TECHNICAL SERVICE BULLETIN

NUMBER	16TSB-86			TYPE	SERVICE ALERT					
ROUTING	INSTALL	X	SERVICE	X	SALES	PURCH				
TITLE	G2 CHAINLIFT CYLINDER PIN DAMAGE - DISTRIBUTE IMMEDIATELY TO ALL INSTALLERS AND AFFECTED PLOW OWNERS									
REV	A			ISSUED	12/7/2018		REVISED	-		
AFFECTS	ALL SNOWDOGG G2 PLOWS - HD2/EX2/VXF2/TE2 - PRIMARILY VXF2

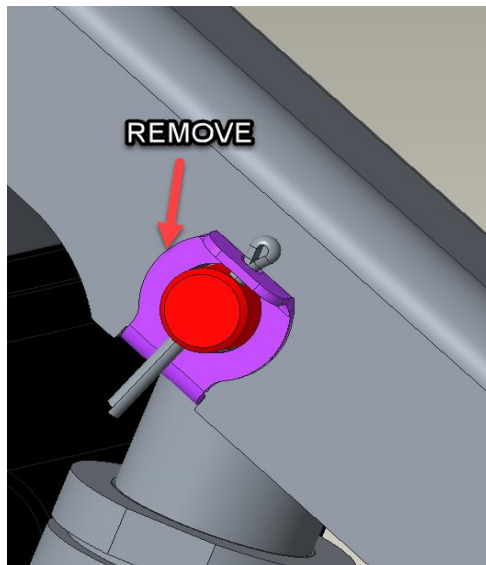
We've received reports of the cotter pin on the chainlift/cylinder clevis pin failing. If not detected, this can cause the clevis pin to come loose and the cylinder to **cause further damage to the plow/lift frame.**

REMOVE THE ANTI-ROTATION PLATE. The plow will function normally but premature wear of the clevis pin or chain lift may result.

Replace the anti-rotation plate and cotter pin with part number 16111402A. This is an anti-rotation plate with a alloy steel socket head screw. The #10-24 x 1.50 screw is readily available at most hardware stores.

16111402A will be available by 12/12/18 for order and will be treated as a warranty item. All plows in stock and previously sold should be updated to this kit.
